THE SUPERHEATER CO LTD BUSH HOUSE LONDON W C 2	
TITLE	ARRANGEMENT OF SUPERHEATER "R.B" TYPE.
REVISED	DRAWING NO 2
ORDERING	6117M 2/11/34
6118M 2/11/34	MN 5160
JOHN DICKINSON & SONS LIMITED	
CONTRACT NO 255 AND 256	
CONTRACT NO 260 AND 261	
CONTRACT NO 271 AND 272

SCALE
1" = ONE FOOT
DWG NO 101X/34
3/11/32

SPACERS TO BE WELDED BETWEEN ALL ELEMENTS
EXTENDING 9" OR 6" INSIDE 90

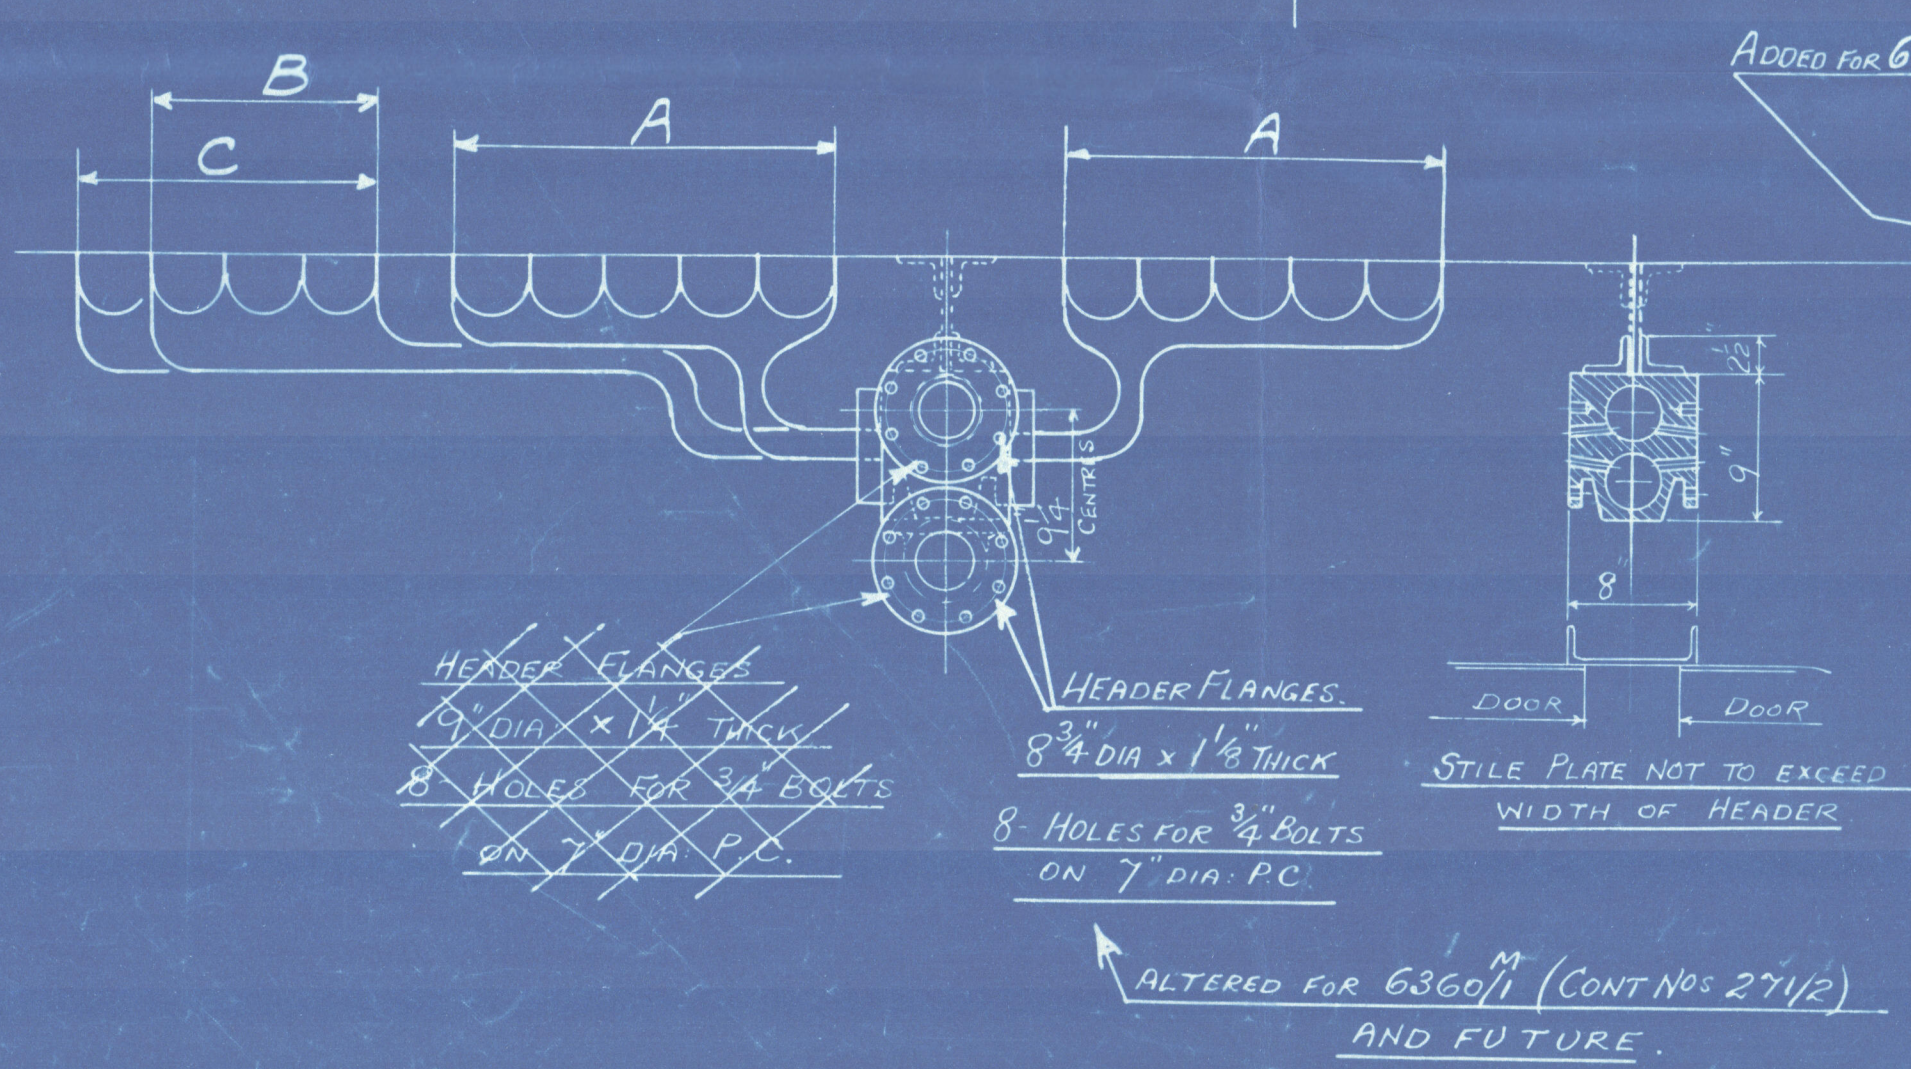
REVISION	REMARKS
(A)	ELEMENTS EXTENDED INTO COMBUSTION CHAMBER
(B)	BASE PLATES ADDED FOR 6162/3M, (NOTING 260/1)
(C)	HEADER & ELBOW FLANGES ALTERED FOR 6360/1M AND FUTURE
